The U.S. Environmental Protection Agency has conducted a complete review of the Total Maximum Daily Load (TMDL) for Miller Creek, located in St. Louis County, Minnesota. The TMDL is calculated for heat, and addresses the temperature impairment to the Aquatic Life designated use.

## Decision Document for the Approval of the Miller Creek Total Maximum Daily Load

Miller Creek Water Temperature Total Maximum Daily Load  
Prepared by Minnesota Pollution Control Agency  
October 2017  
Received by EPA Region 5 October 18th, 2017.

Figure 13: MS4s within Miller Creek Watershed (South St. Louis SWCD).

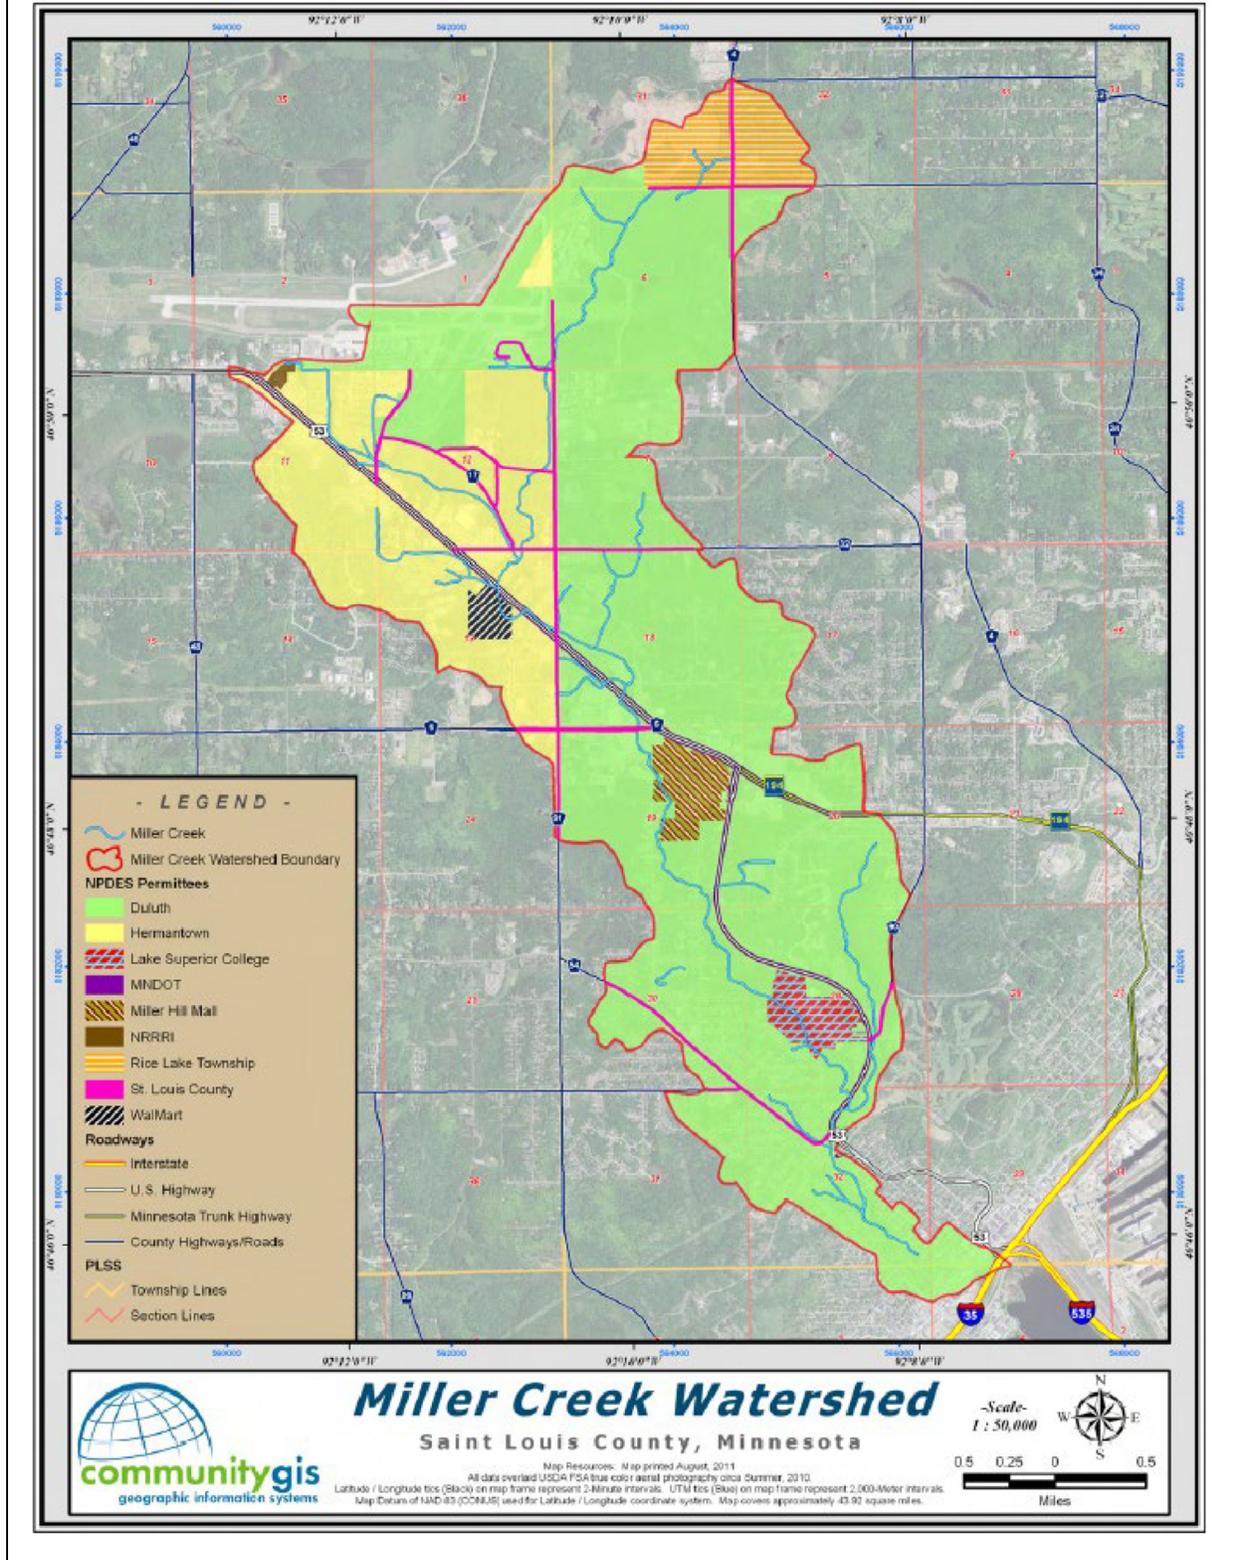
No industrial point sources or municipal WWTP are identified as sources of heat to the impaired waterbody. Permitted point sources in the form of construction stormwater, industrial stormwater, and MS4s are identified as sources of heat and allocated waste loads. [Figure 13](#) of the TMDL document provides a map showing the watershed boundaries and the location of permitted MS4s in the watershed. Atmospheric heating is identified as a primary non-point source of heat as well as non-municipal stormwater sources including Walmart Store #1757 (MN0060372) in Hermantown and Miller Hill Mall (MN0056979). Additional unregulated stormwater runoff, consisting of runoff that reaches the waterbody without MS4 infrastructure, is considered to be a very small fraction of total runoff and was not specifically quantified.

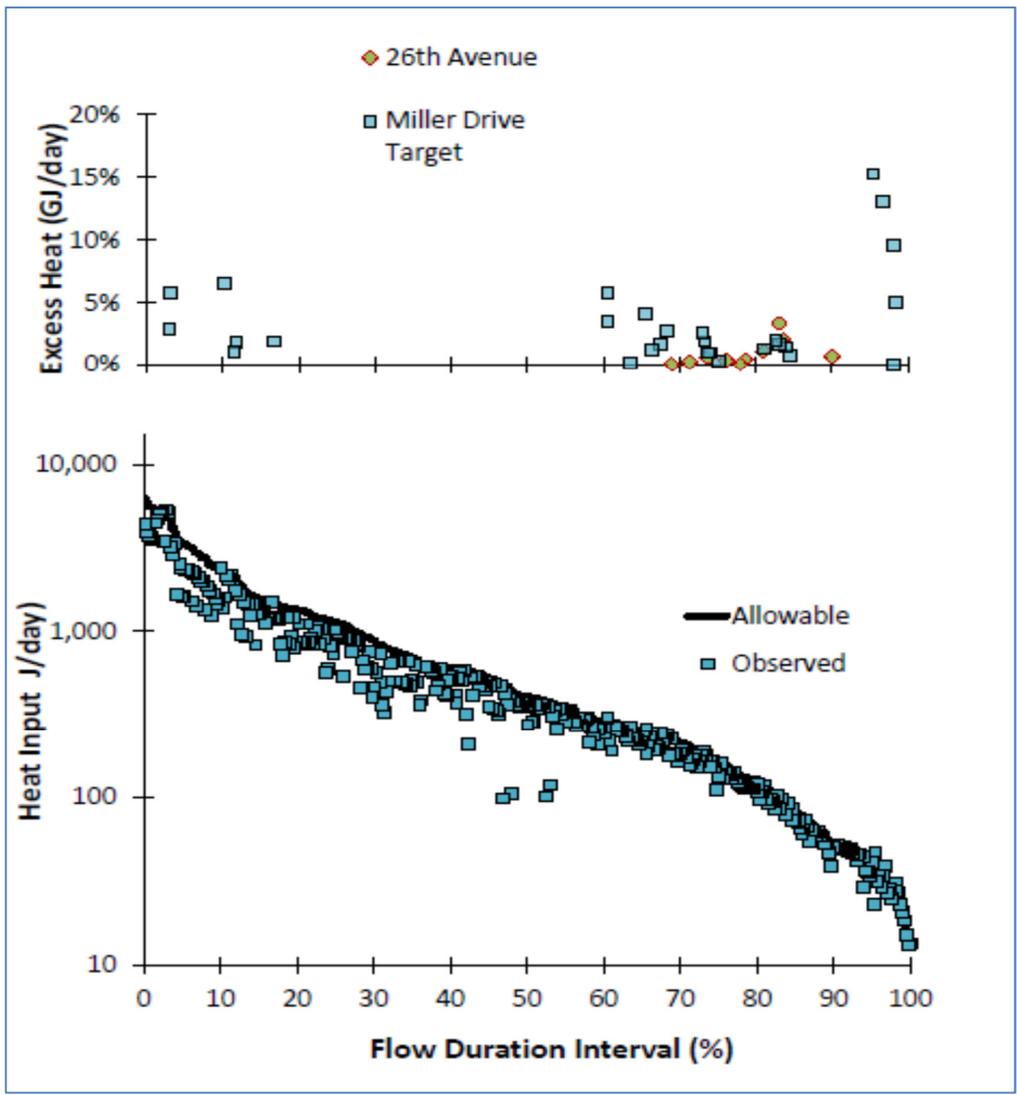
[Figure 12](#) of the TMDL document presents loading capacity of the waterbody for “Heat Input” in the form of a flow duration curve in units of joules per day (J/day). Joules are a unit of energy (similar to calories or BTUs), whereas temperature is a measurement of energy density.

*[Figure 12](#) depicts actual (observed) and allowable heat inputs to Miller Creek, plotted as a function of stream flow as load duration curves. Flow data is from the 26th Avenue West station (2007 to 2009), and excess heat data is derived from observed stream temperature values (2007 to 2009). The lower graph shows the values of observed and allowable heat inputs on a log scale. The upper graph shows the difference between the observed and allowable (excess) heat. [Excerpted from the TMDL Document]*

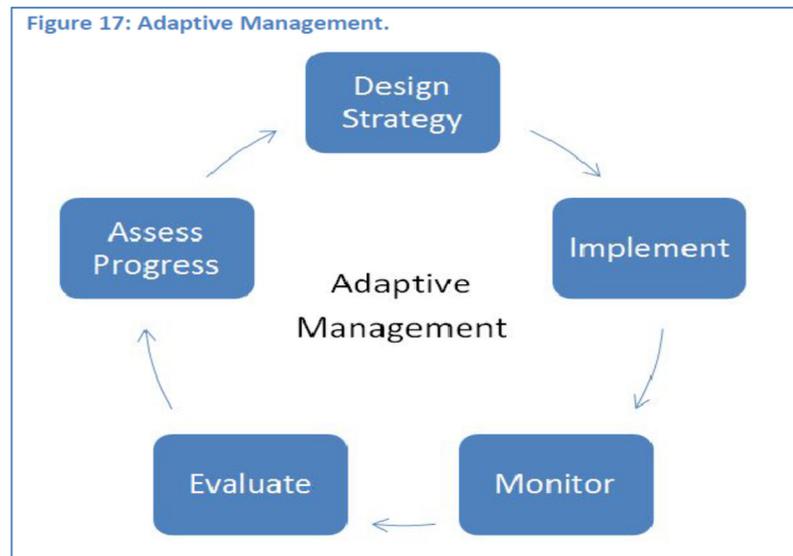
As discussed in Section 8 of this review, the load reductions called for by the TMDL appear to be feasible to achieve. However, uncertainty remains on whether sufficient opportunities will be available to increase riparian shading to reduce atmospheric heat gains. As ongoing implementation continues it will be important for responsible authorities to remain flexible to take advantage of opportunities to cooperate with MS4s and other stormwater permittees and landholders. An adaptive management approach will be needed as is discussed in Section 8.4 of the TMDL document and presented in [Figure 17](#) of the TMDL document.
